# 2006 International Residential Code Errata

(Portions of text and tables not shown are affected by the errata)

1<sup>st</sup> through 8<sup>th</sup> PRINTING (Posted: 09-26-13)

FIGURE R703.7.2.2  
EXTERIOR MASONRY VENEER SUPPORT BY ROOF MEMBERS

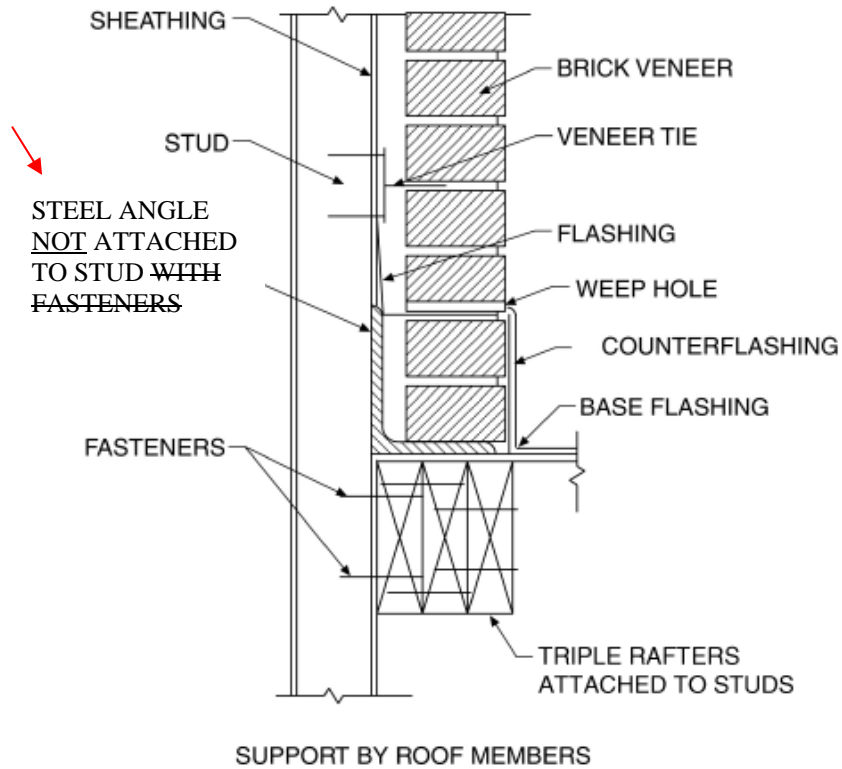
Figure 703.2.2
